FINAL ENVIRONMENTAL STATEMENT

**TIJUANA RIVER
FLOOD CONTROL PROJECT
SAN DIEGO COUNTY, CALIFORNIA**

**UNITED STATES SECTION
INTERNATIONAL BOUNDARY AND WATER COMMISSION**

MAY 1976

INTERNATIONAL BOUNDARY AND WATER COMMISSION UNITED STATES AND MEXICO TIJUANA RIVER FLOOD CONTROL PROJECT
PROPOSED PLAN
LEVEED ENERGY DISSIPATOR

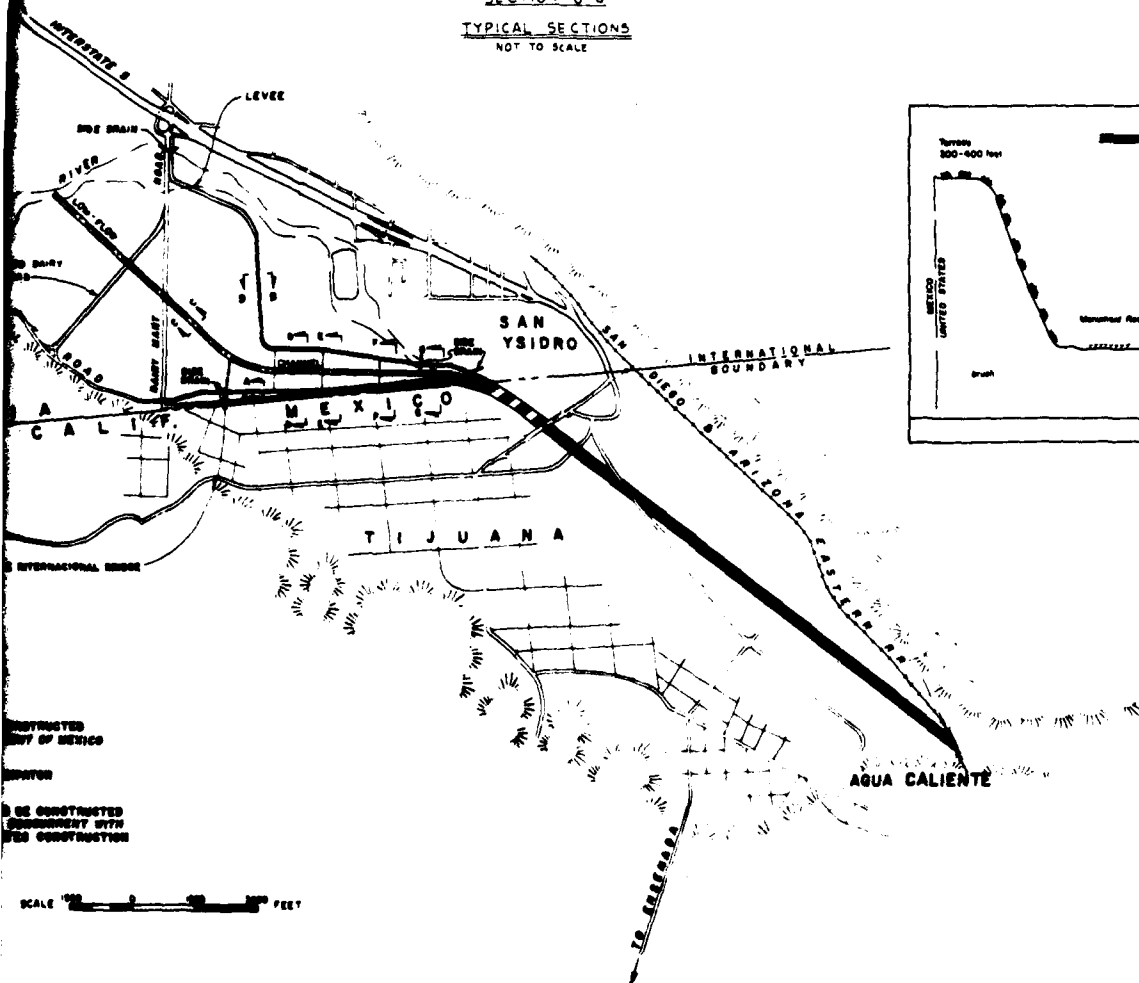
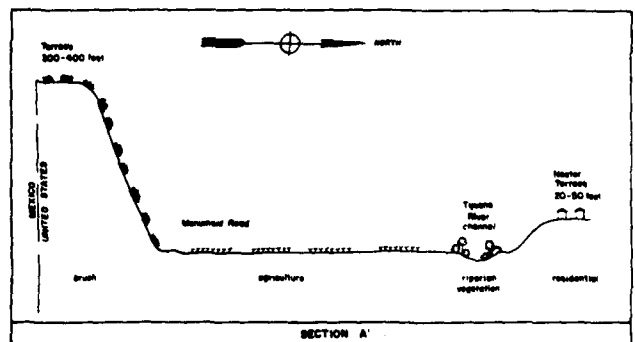
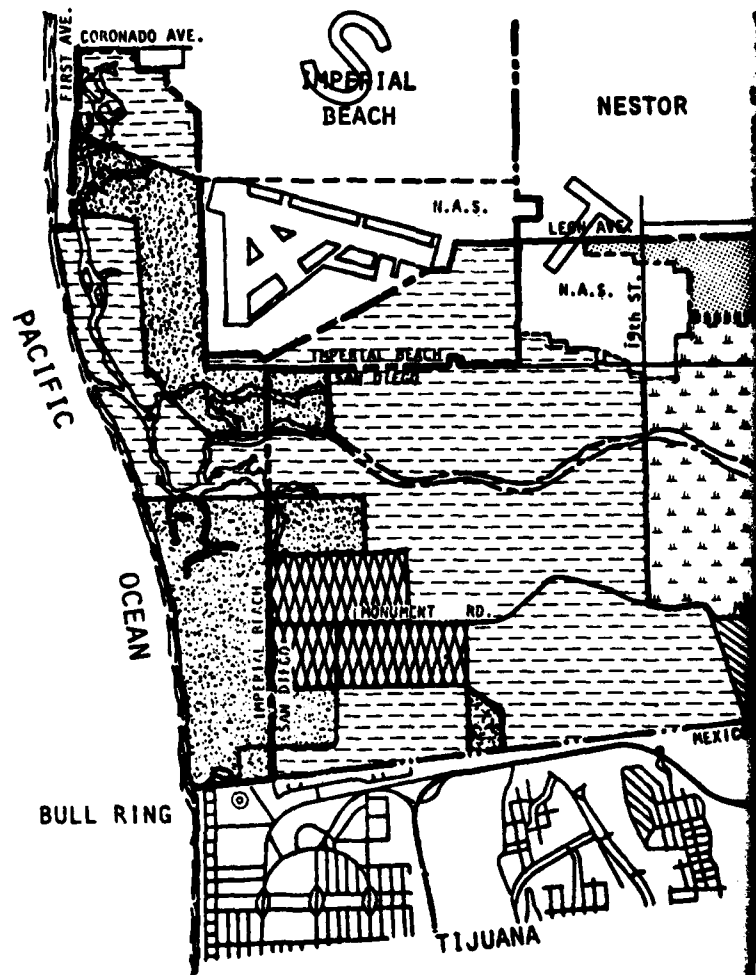
Comment: We note that discussion of the levee system is limited to paragraph 7 (c) on page 3 of the Statement and the drawing provided on plate 2. Neither the discussion in paragraph 7 (c) nor the drawings in plate 2 contain sufficient technical data to allow a realistic appraisal of the system's effectiveness by an expert. It is suggested, therefore, that more design detail be included to describe the levee system.

Comment: There is an indication in plate 2 that there will be some riprap protection on the side slopes of the levees. Data as to the depth of the riprap is not provided however. (This would appear to be an important factor to an expert who would be evaluating the effectiveness of the plan.)

PLATE 3

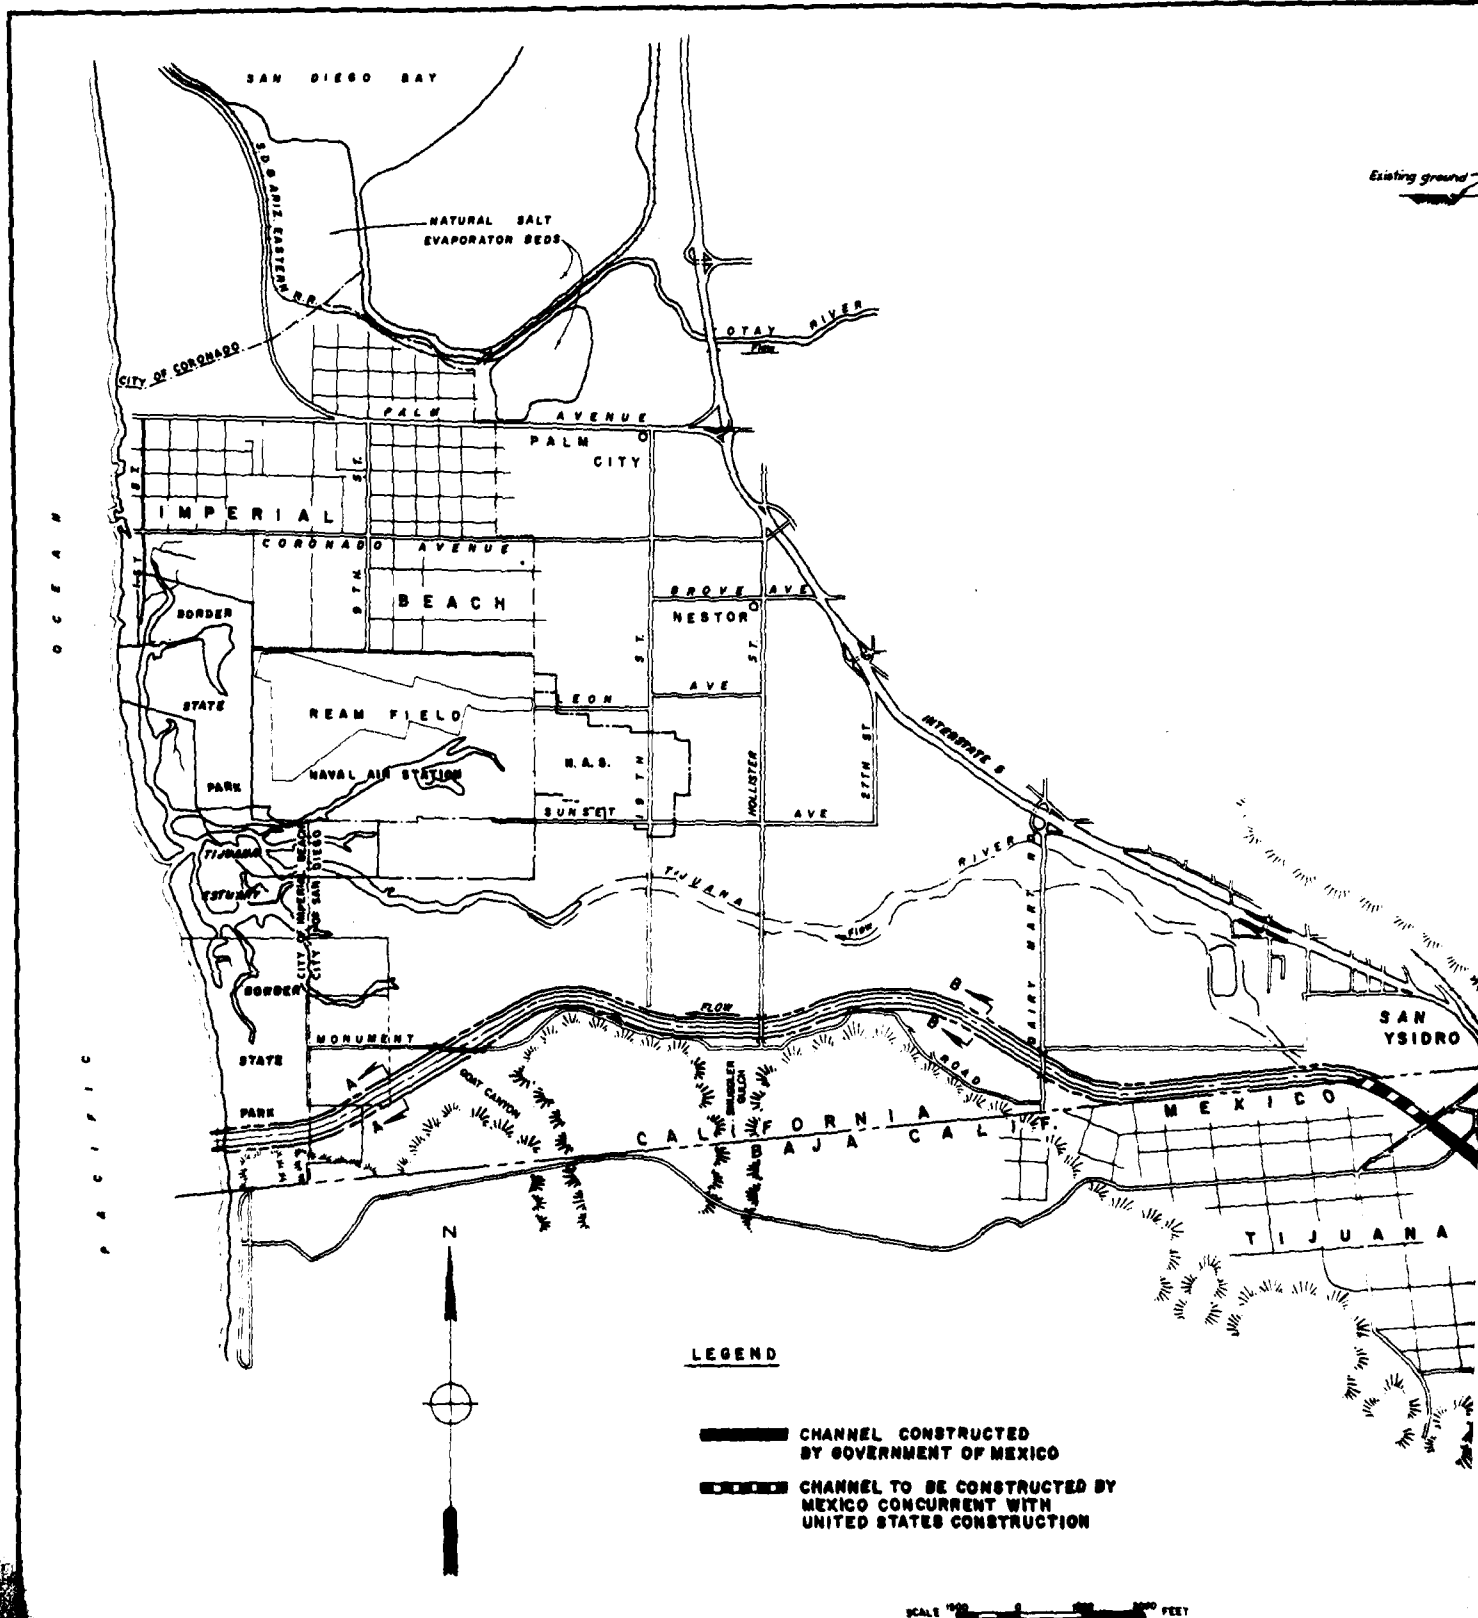
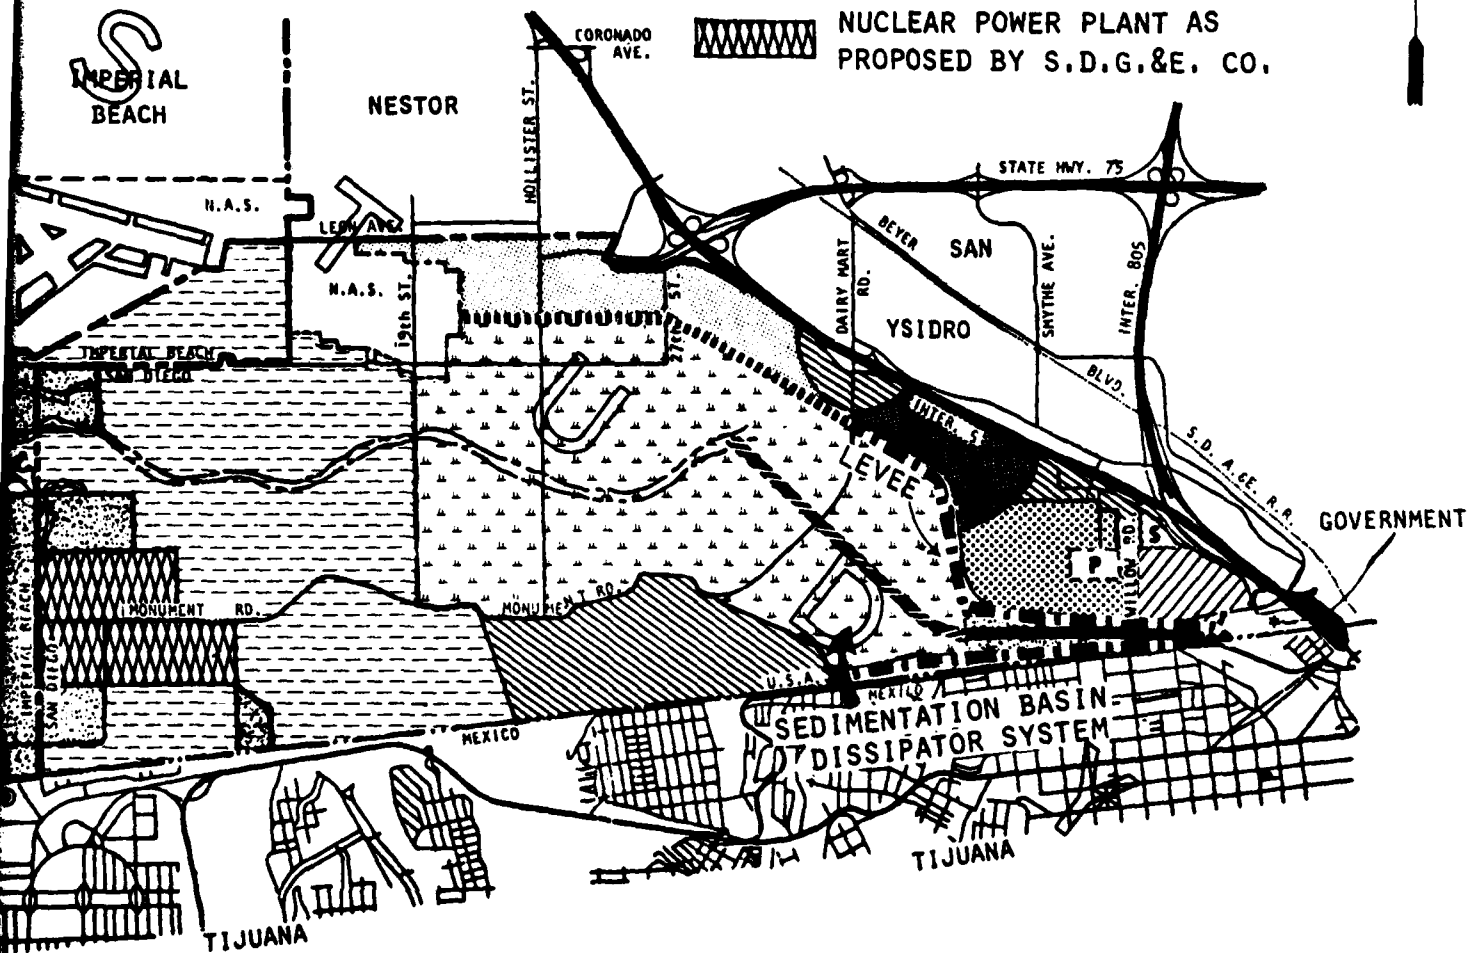
Comment: The designation of a neighborhood park and elementary school south of Monument Road on Plate 3 is incorrect and should be deleted.

Response: The most recent land use plan proposed by the City of San Diego, as shown in the January 1976 Tijuana River Valley Plan and Environmental Impact Report, is shown in Plate 3.
